# Friland Condominiums

Coventry, Connecticut

Environmental Review Team  
Report  
on

March 1982

# Surficial Geology

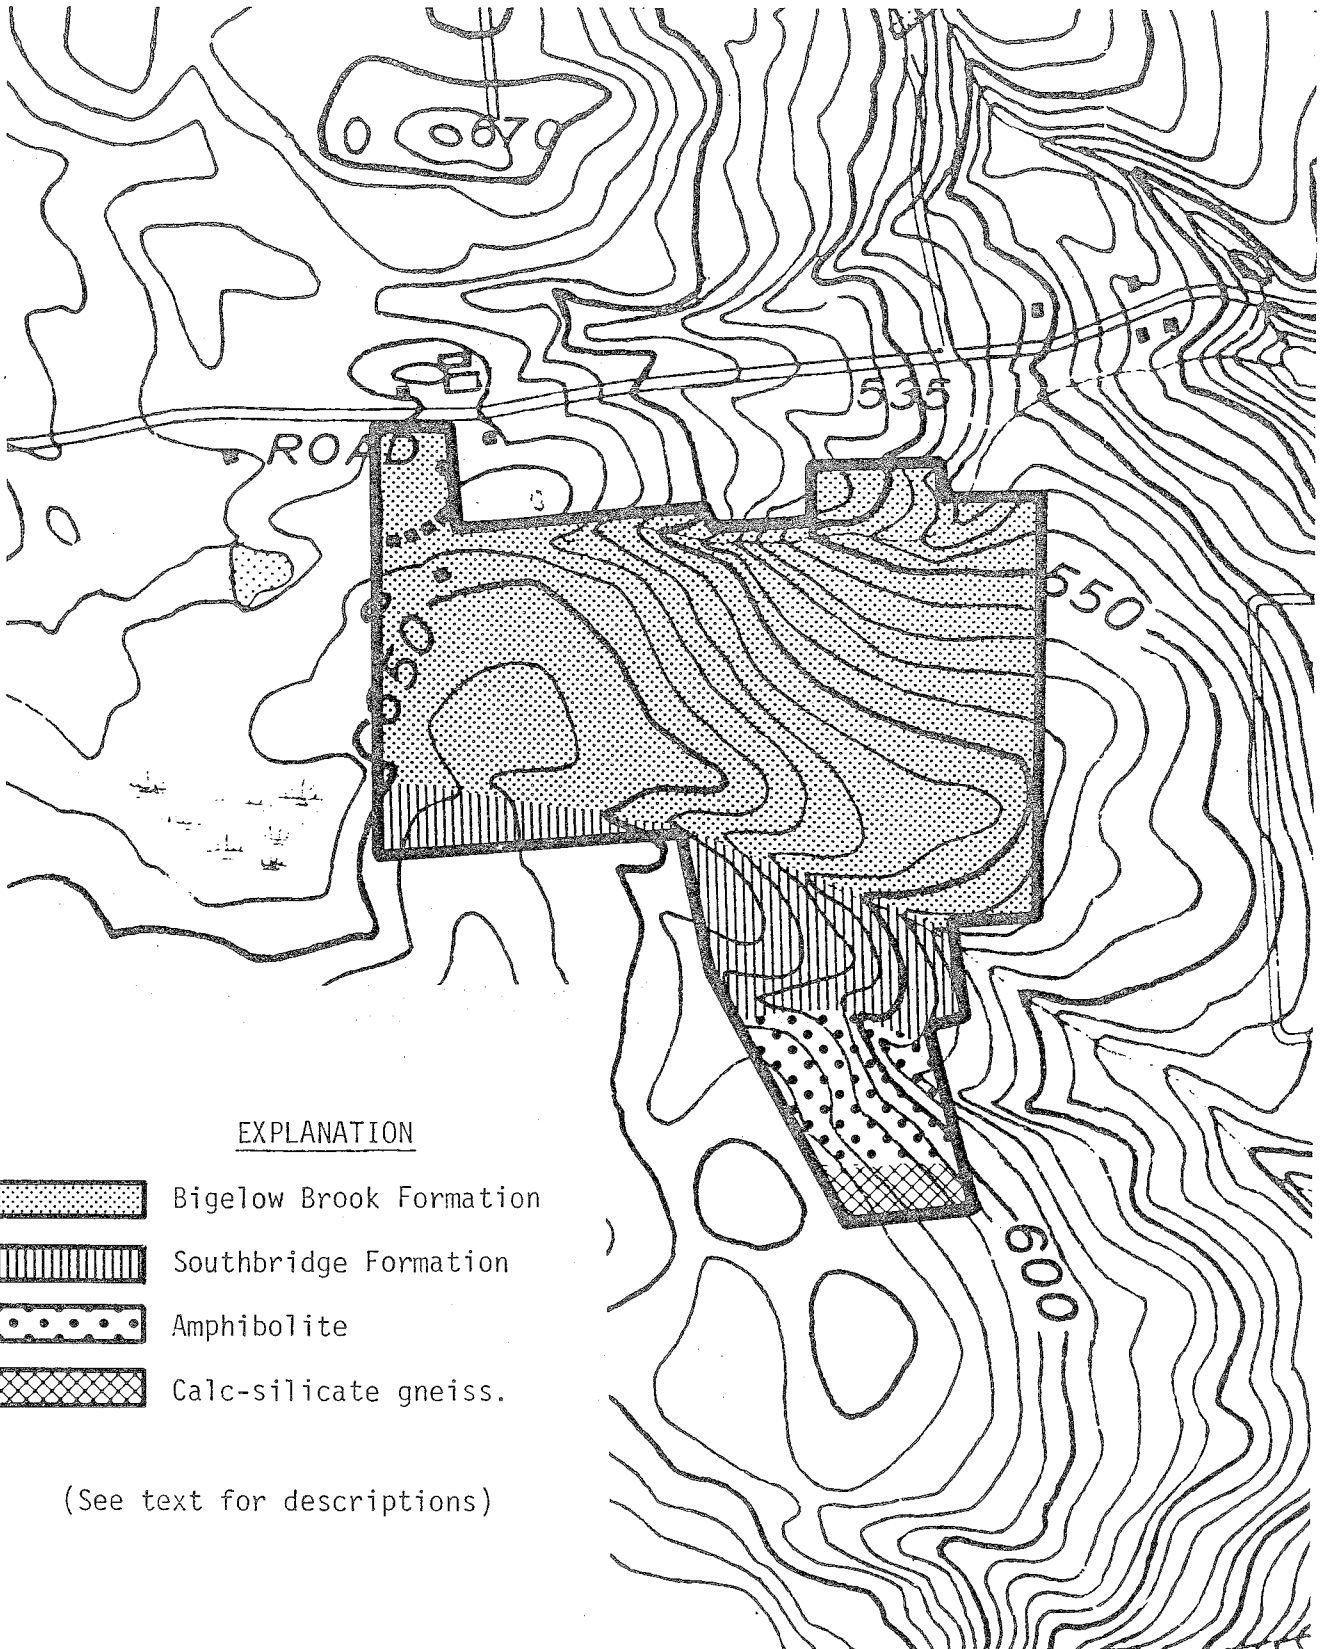
The differences in the bedrock units should not have an effect on construction activities. Variations in mineralogy may have an influence on well-water quality, however. Moderate to excess concentrations of iron and/or manganese are often found in wells in the vicinity of the site. Of the bedrock types underlying the site, the Bigelow Brook Formation and the amphibolite unit are most likely to cause high concentrations of these elements.

In general, the till should pose no difficult problems for development. Stoniness is likely to be a nuisance in some areas, but steep slopes and areas of less rapid subsurface drainage are more likely to limit local development potential than the nature of the till itself. Shallow-to-bedrock conditions are not known to be present on the site, but bedrock is probably closest to the surface along the northernmost brook and in the southeastern corner of the property.

# Vegetation

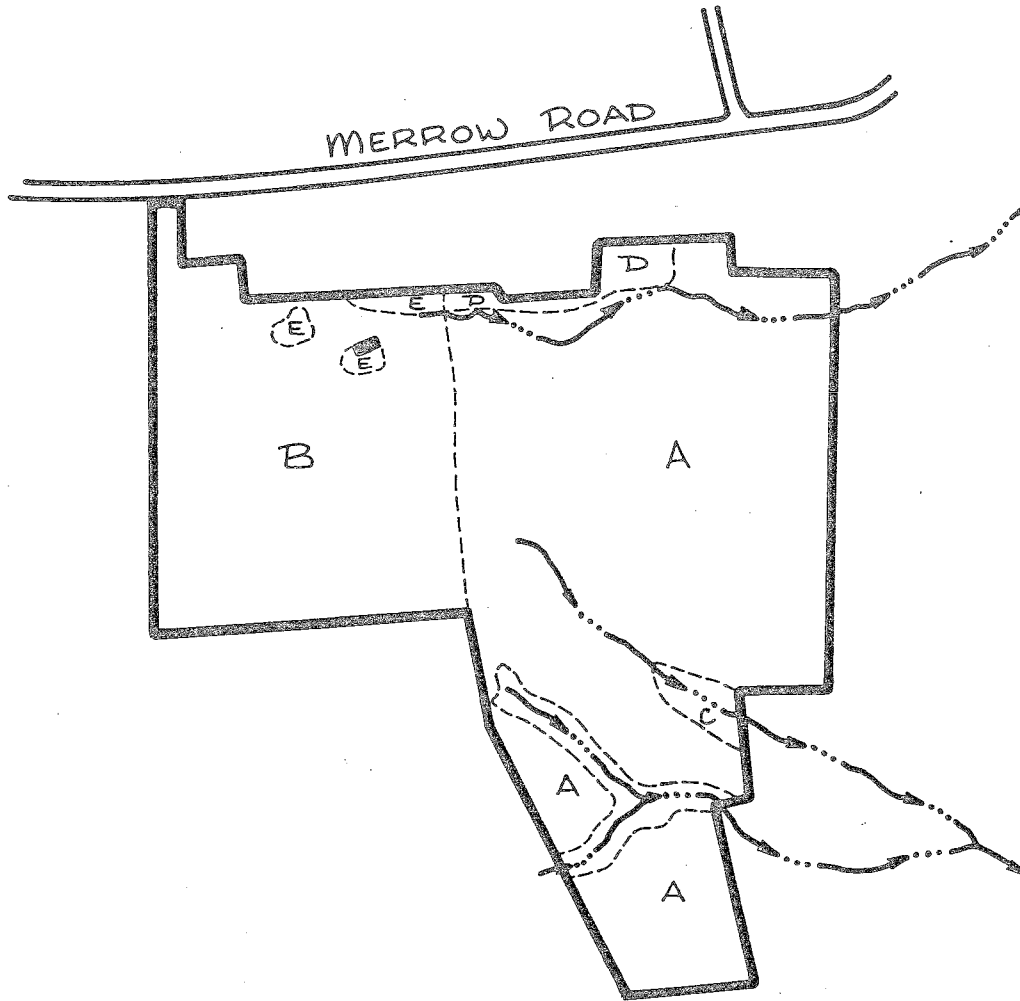
Many of the large healthy trees which are scattered throughout both Vegetation Types A and B have high aesthetic and shade value. As many as possible of these high value trees should be selected for retention and worked into the final site plan for the proposed development.

The loss of trees due to windthrow is a potential hazard in the hardwood swamp/streambelt areas (Vegetation Type C). In these areas, the soils are saturated with water causing soil aeration to be poor. These conditions result in unstable, shallow root systems which are unable to securely anchor trees. Trees which are crowded and rely on each other for stability have an even greater potential for windthrow problems and top breakage. These conditions may be intensified if linear openings, which allow wind to pass through rather than over these areas, are made. Openings and clearings in and along side these wetland areas should be avoided if at all possible. Light thinnings in these areas may, however, help to improve tree stability.

The trees which are present in Vegetation Types A and C are declining in health and vigor as a result of their crowded condition. Under these circumstances, the trees are under stress and major disturbances in their environment, such as changes in soil conditions and mechanical injury caused by construction in these areas, may rapidly lower their health. A small-sawtimber or fuelwood thinning in Vegetation Type A, following the "crop tree selection method" preferably prior to development of this property would help to reduce the crowded condition and improve tree health and vigor.

The open fields which are located along the northern boundary of this parcel could be planted with conifers. Eastern hemlock and white pine, if planted in several staggered rows approximately eight to ten feet apart, will eventually produce an effective vision barrier between this complex and the single family residences along Merrow Road.
